ADDENDUM NO. 24

**Westfield Washington School Corporation
Bid Package 06, Bid Item #33
SR32 & Centennial Road New Roundabout Construction
17707 Centennial Road,
Westfield, IN. 46074**

ADDENDUM NO. 24

RE: Westfield Middle School – West

INDIANA DEPARTMENT OF TRANSPORTATION
TYPICAL SECTIONS

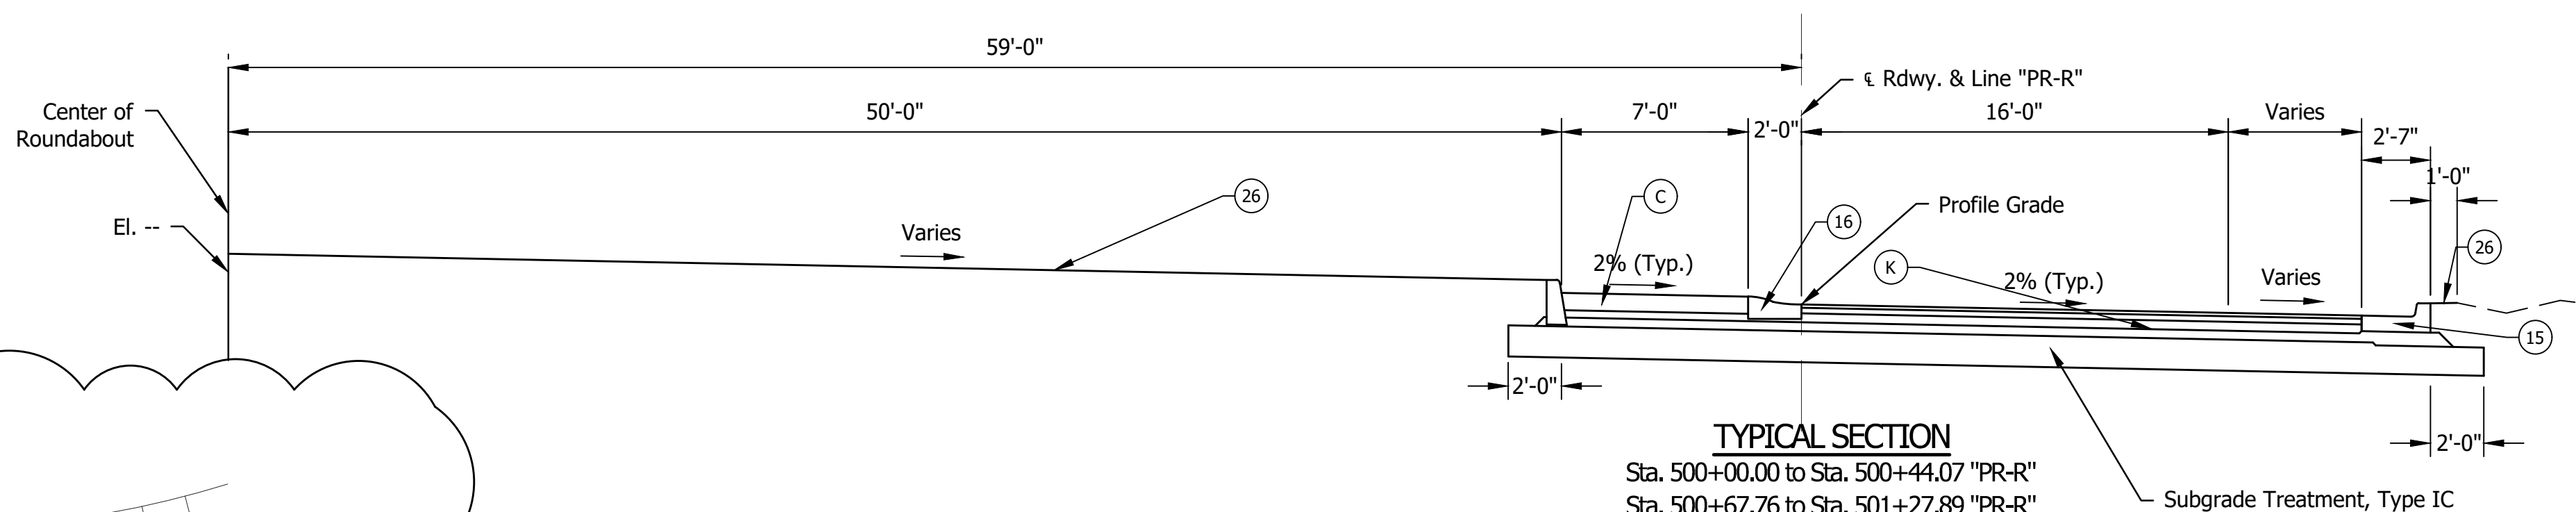
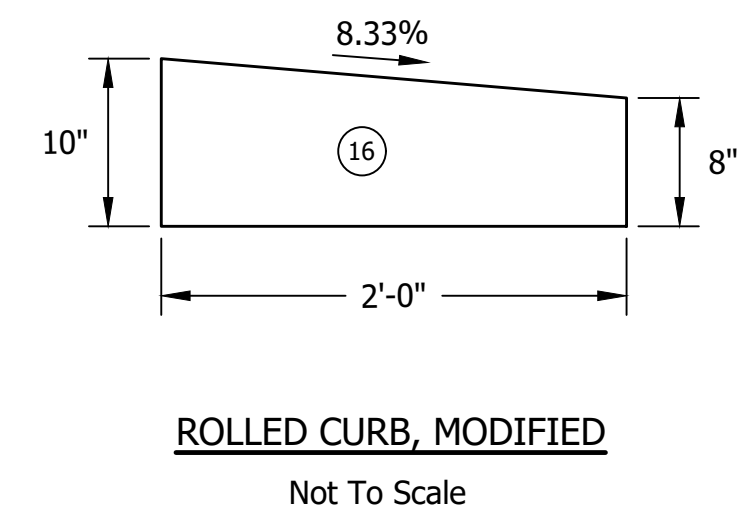
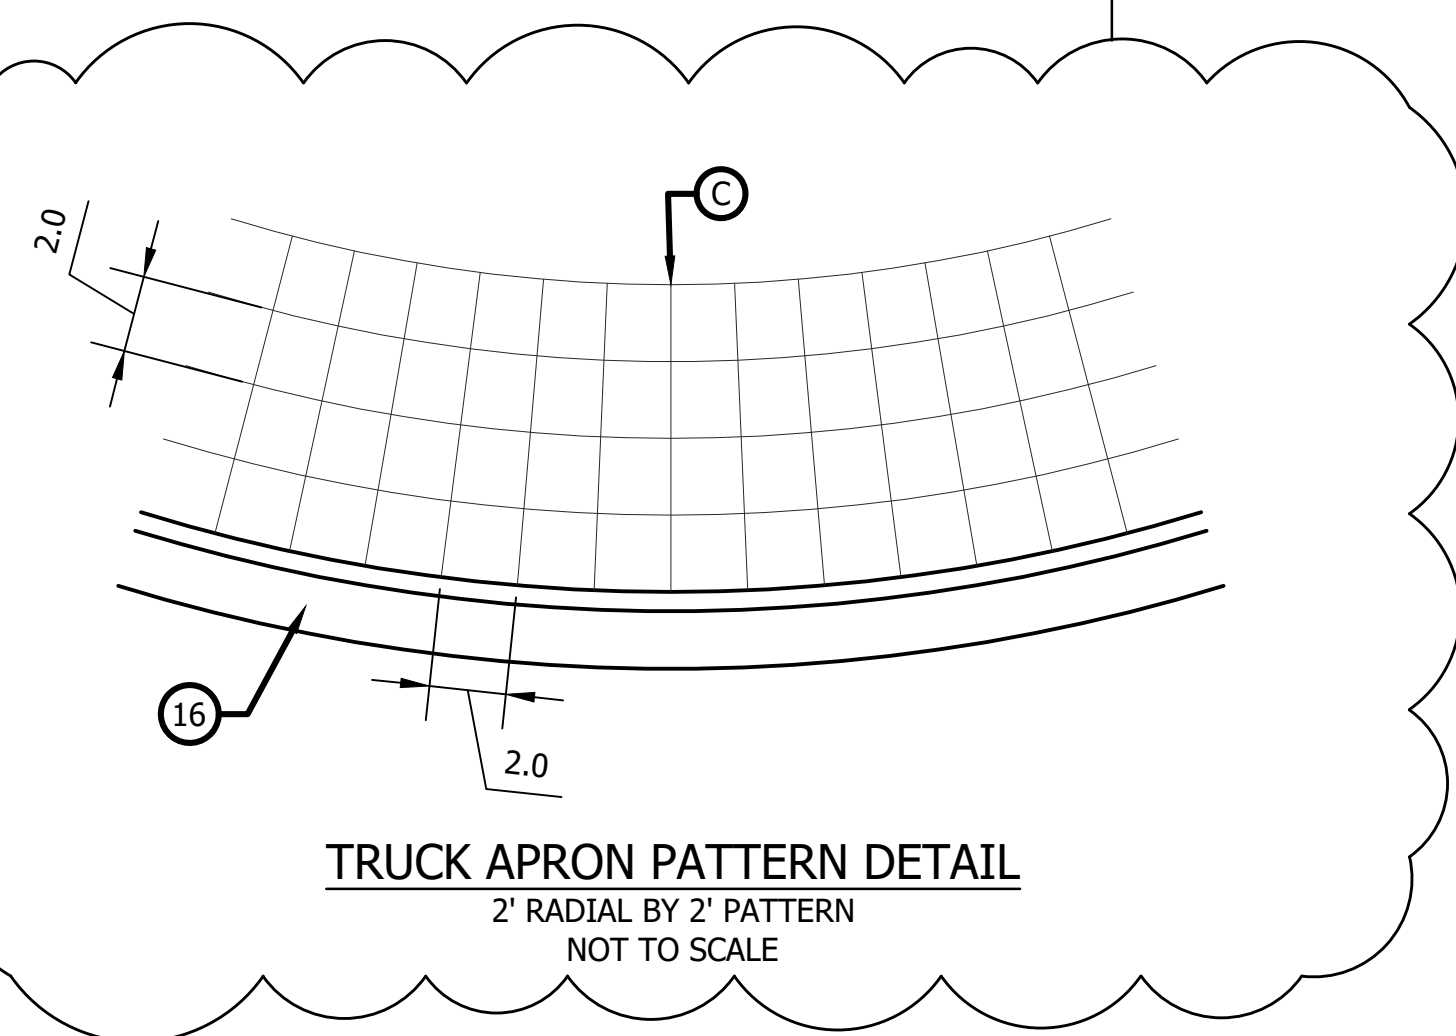
- Sheet 3: updated typical sections based on subgrade treatment changes to the truck apron area and multi-use path; more information is shown regarding the concrete treatment needed in the roundabout truck apron and approach splitter islands.
- Sheets 11, 13, 15, 17, 19: better show grass areas for sod or seeding that were asked about in the pre-bid meeting; earthwork summary table added; subgrade treatment callouts have been updated based on changes elected by the project owner.
- The cross sections on Sheets 29-47 have been updated to include earthwork information.
- Sheet 10A has been added to the plans depicting the existing asphalt pavement that needs to be removed as part of Common Excavation.

REVISIONS	
DATE	ITEM
09-28-2026	Added Truck Apron Detail
	Edited Subgrade

Q. The truck apron cross section calls out for stabilized subgrade while the rest of the project calls for Subgrade Treatment, Type IC. The radius for the apron will be too narrow for a tiller to stabilize just that area. Would you consider switching to Type IC here also?

A. The plans have been updated based on this question and discussion at and after the pre-bid meeting to gain a good outcome for WWS. The subgrade treatment on the mainline pavement will be used under the truck apron and multi-use path. The plans have been updated to reflect these changes.

PAVEMENT REMOVAL EXHIBIT

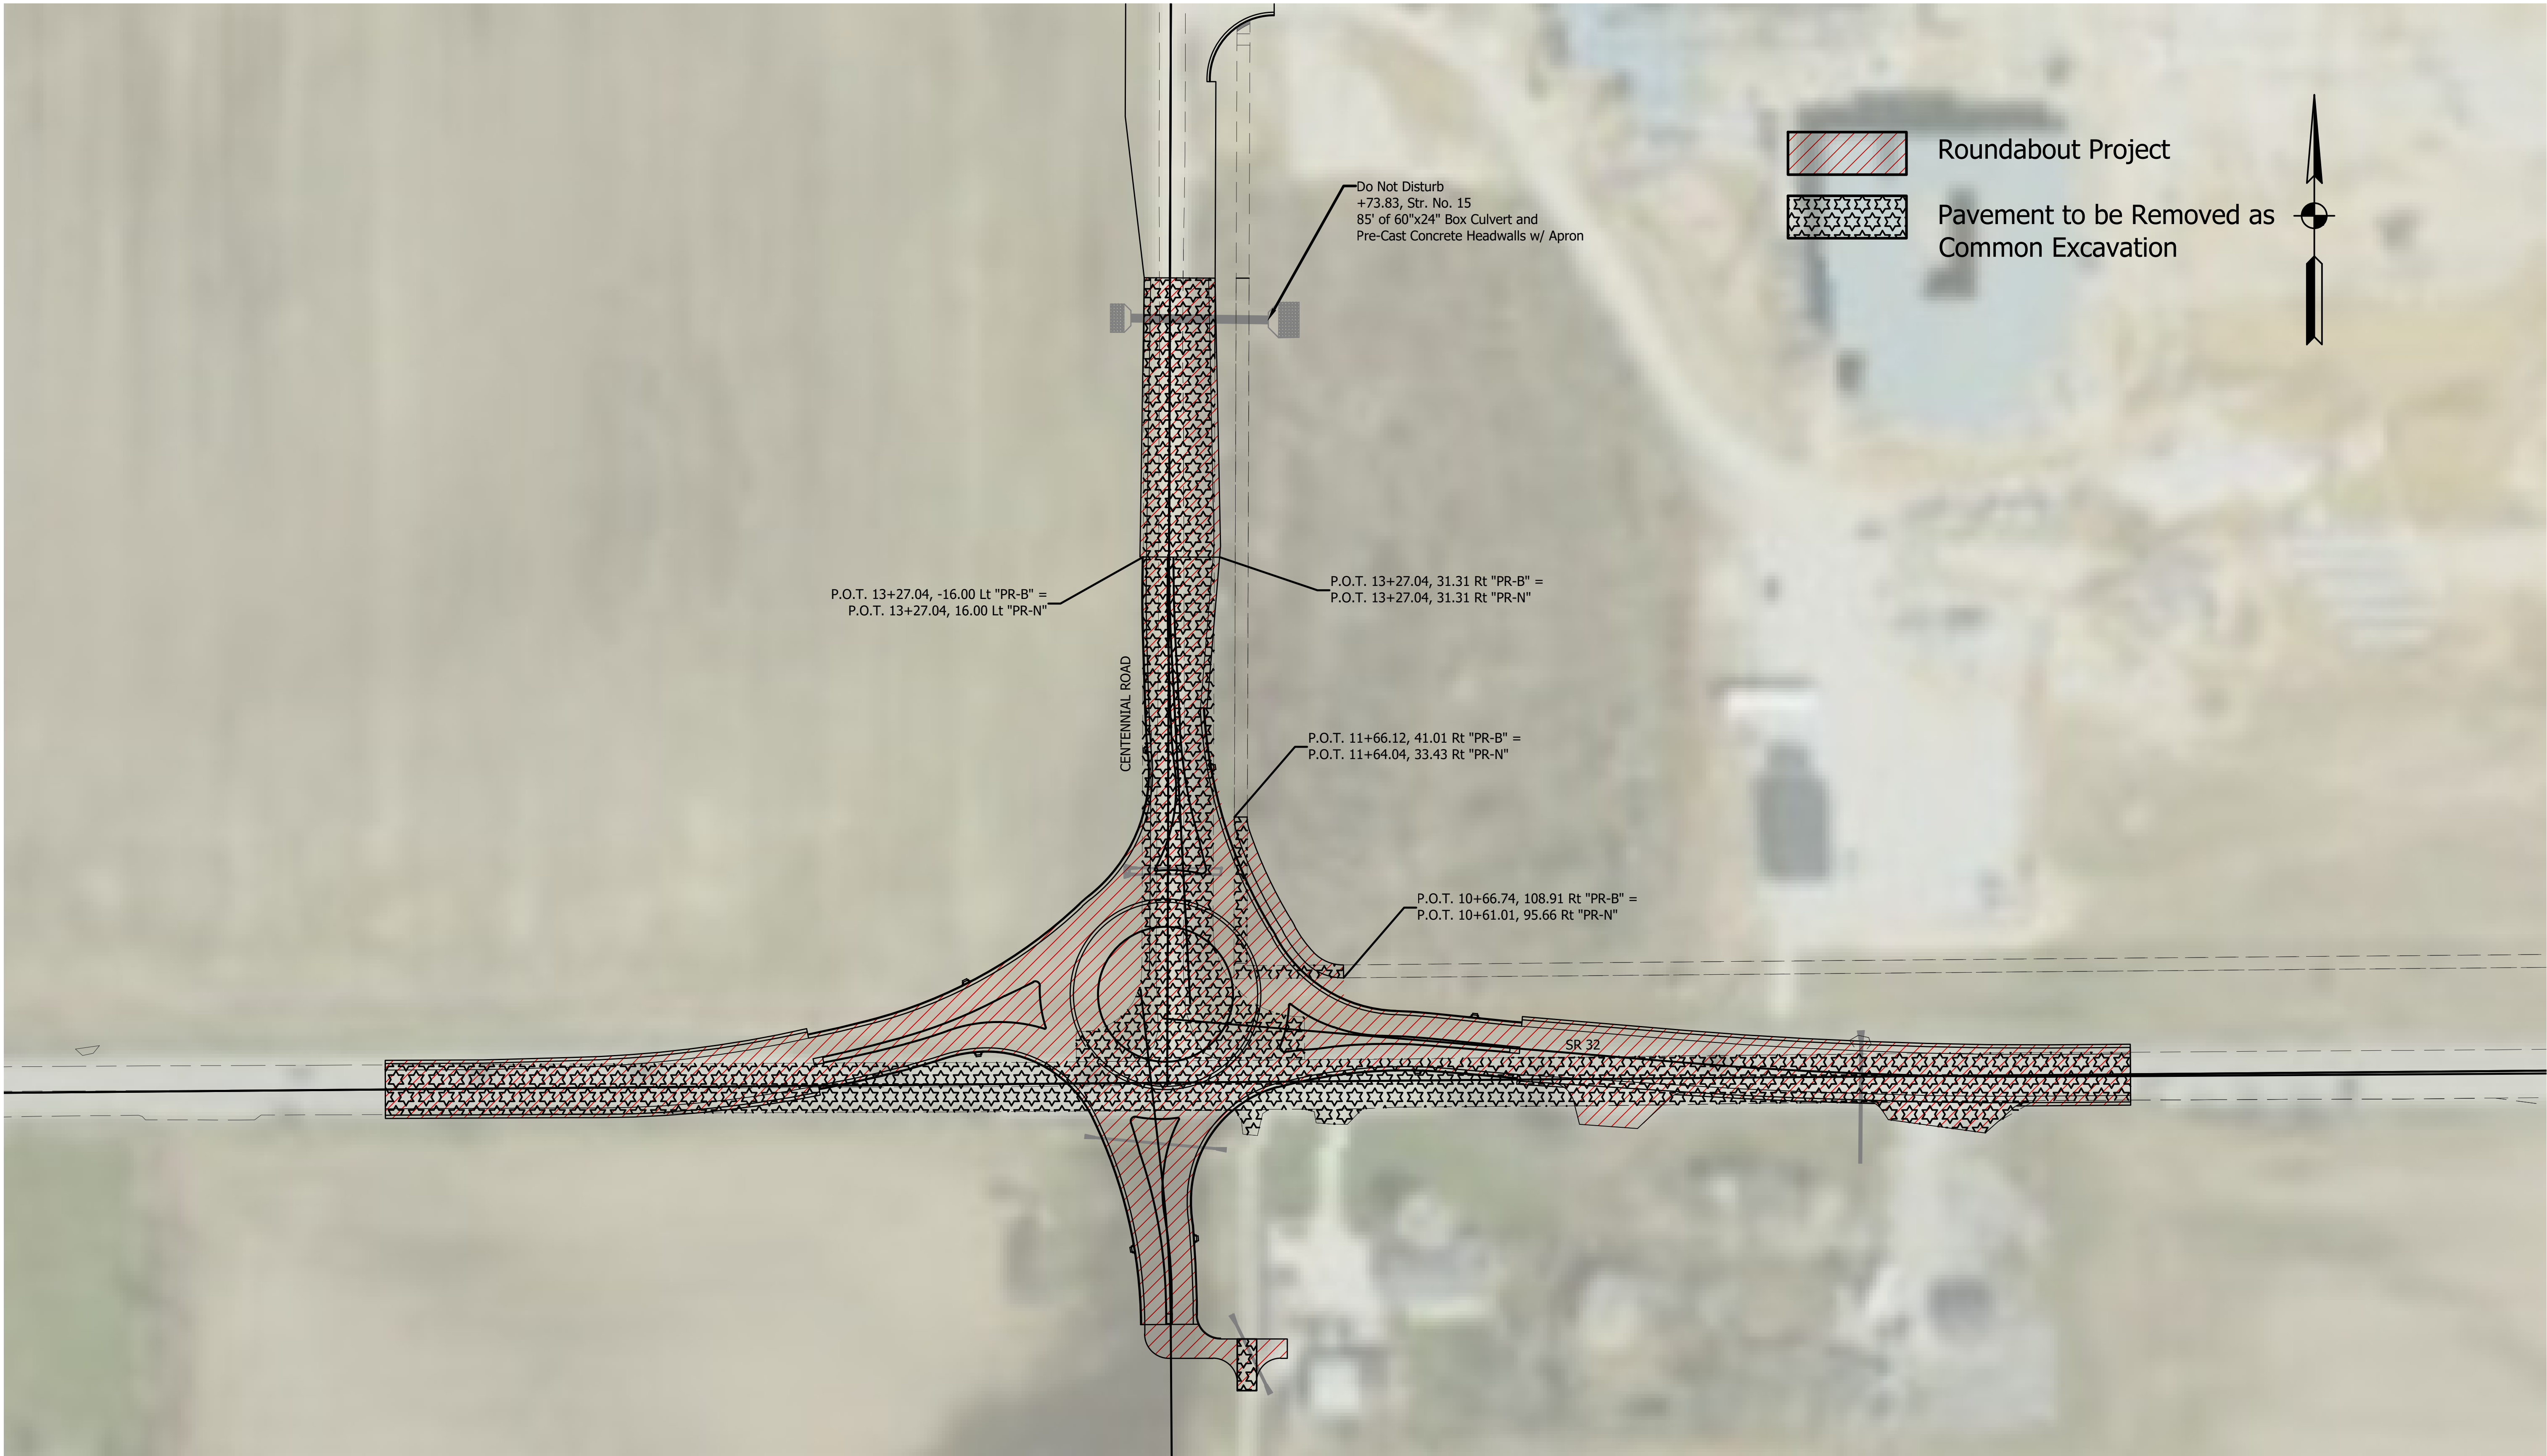
4.2 Sheets 2, 3-4, 11, 13, 15, 17, 19, 29-47; new sheet 10A

REVISIONS	
ITEM	
09-17-2026	Adjusted South Leg to shorten project.

PLAN - LINE "PR-W"
STA. 50+00.00 TO STA. 56+00.00

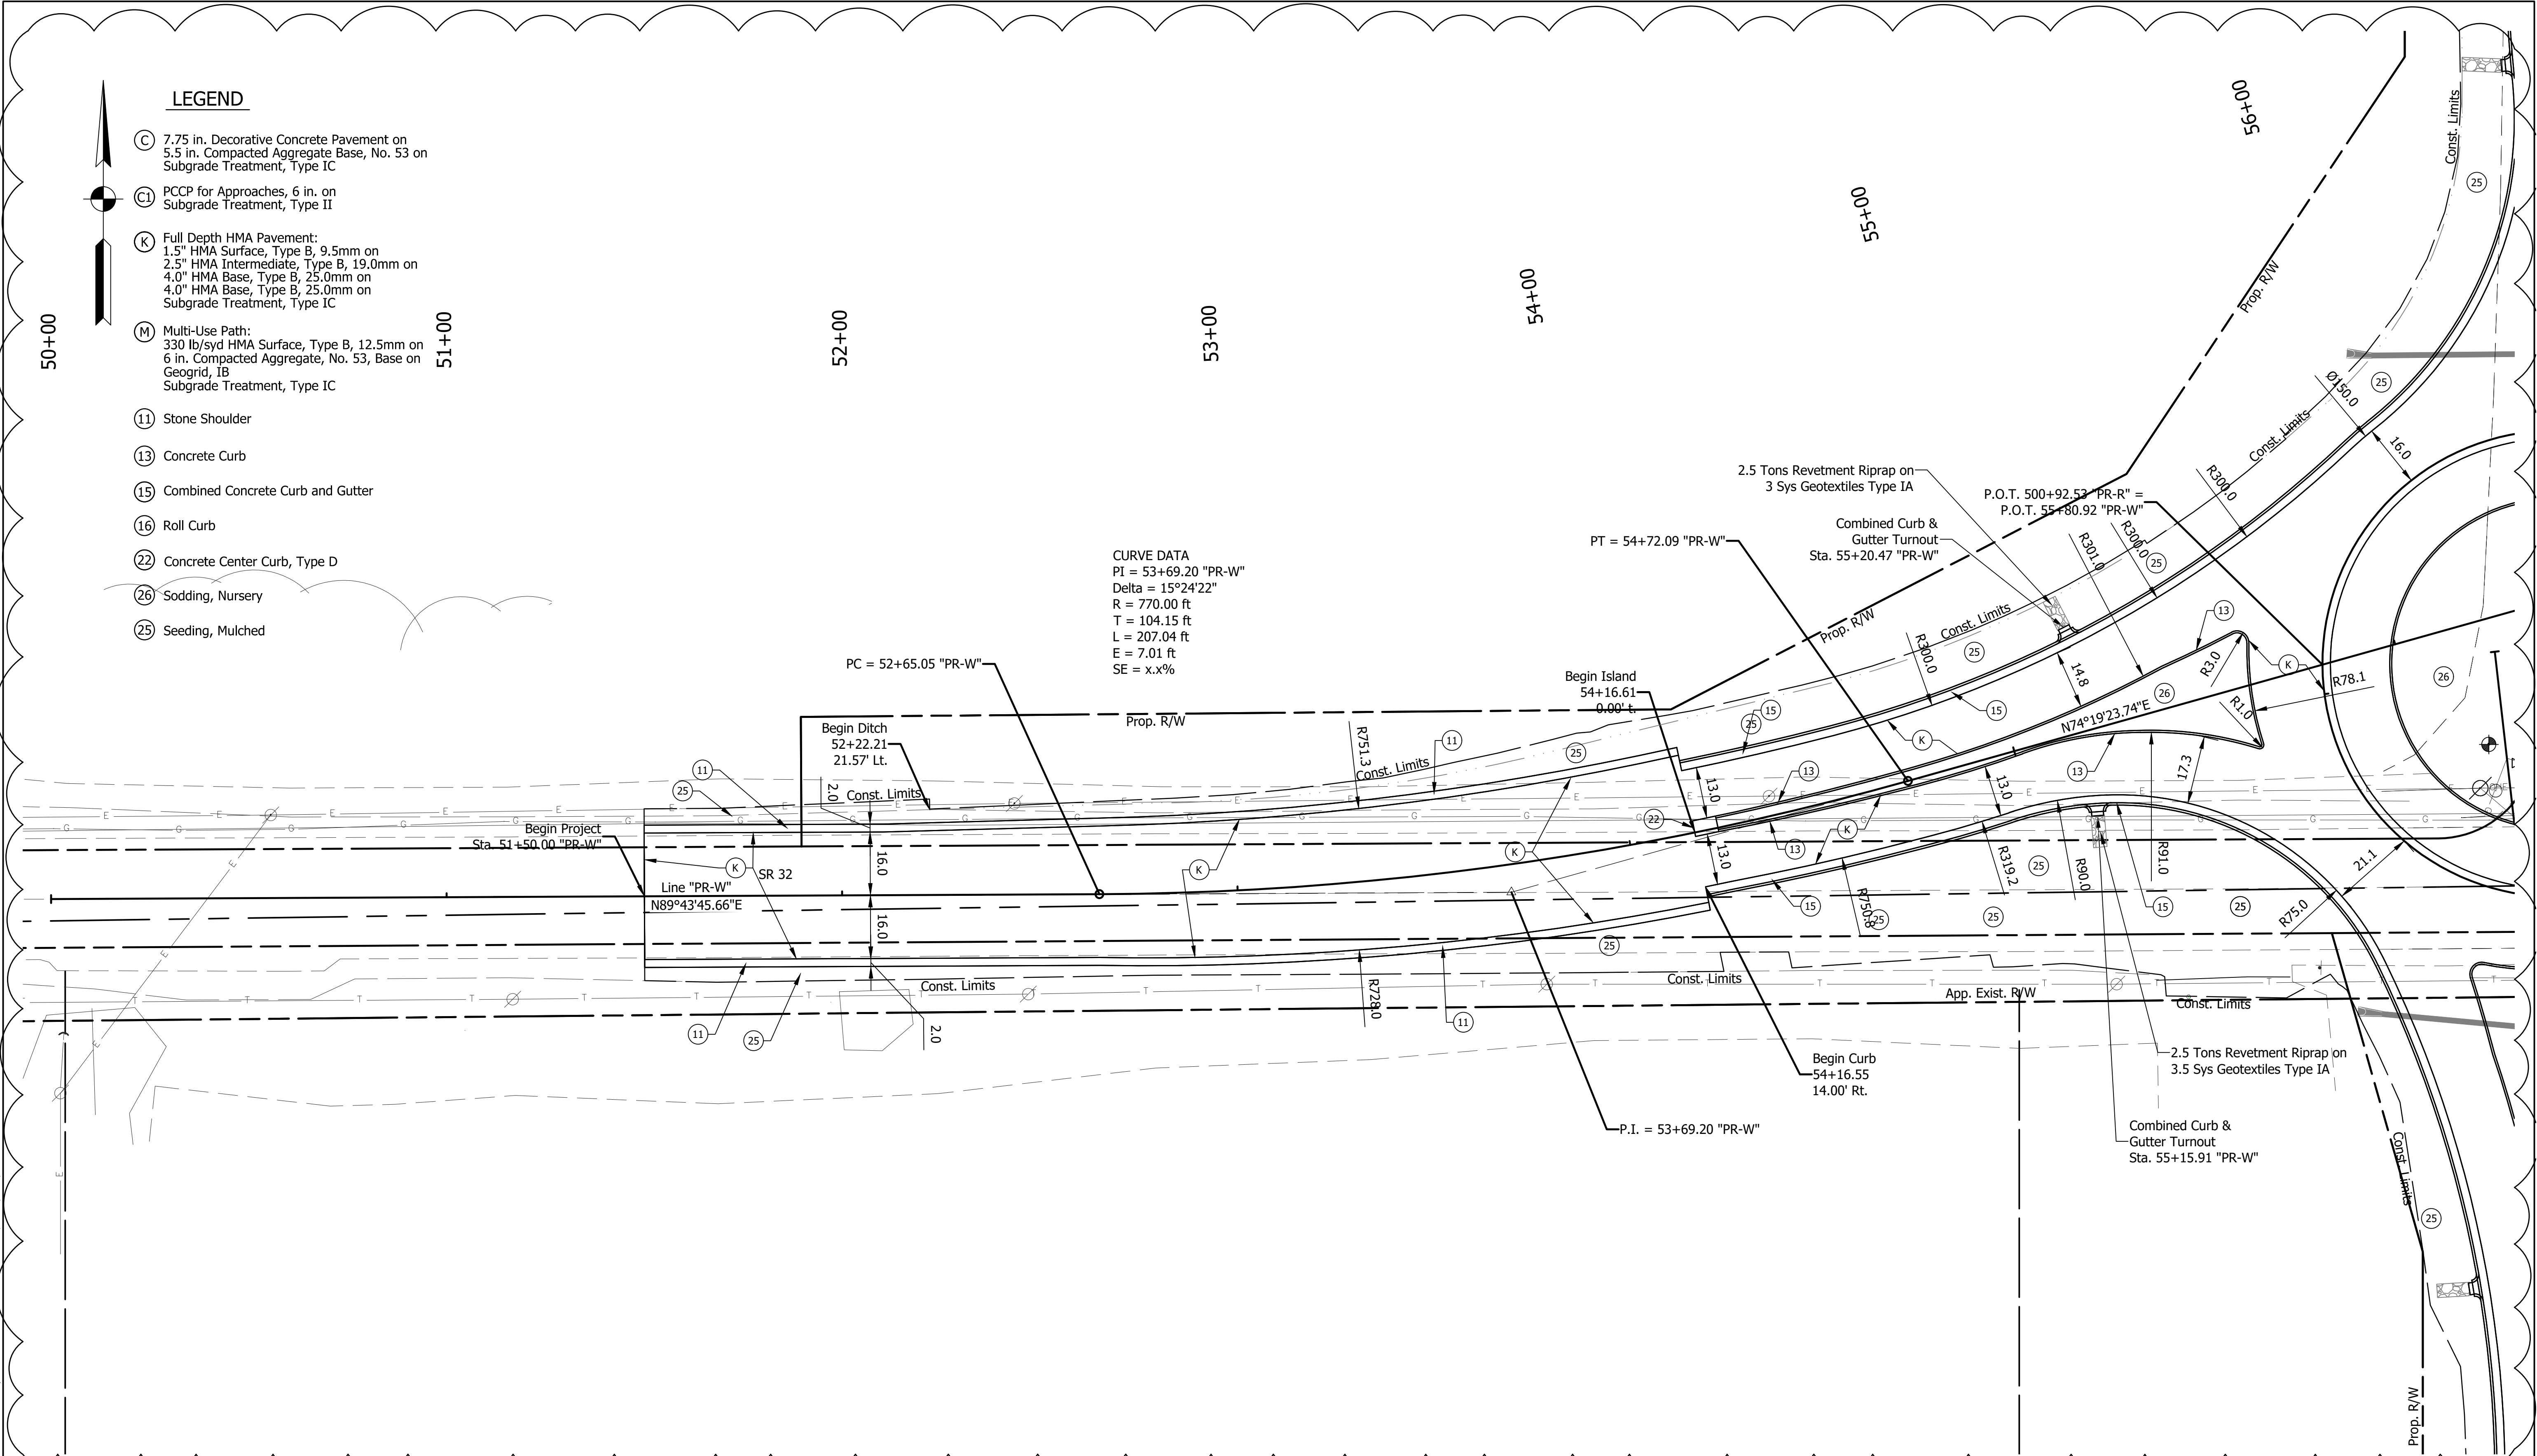
REVISIONS	
DATE	ITEM
09-28-2026	Added Construction Limits, Seeding Locations, Earthwork Summary Table, Changed Subgrades

A. Sodding and seeding callouts in the plans have been modified and updated for clarification. Sod is required in the central island and in the corner between curb and multi-use trail, and mulched urban seeding is used in the other disturbed project areas.
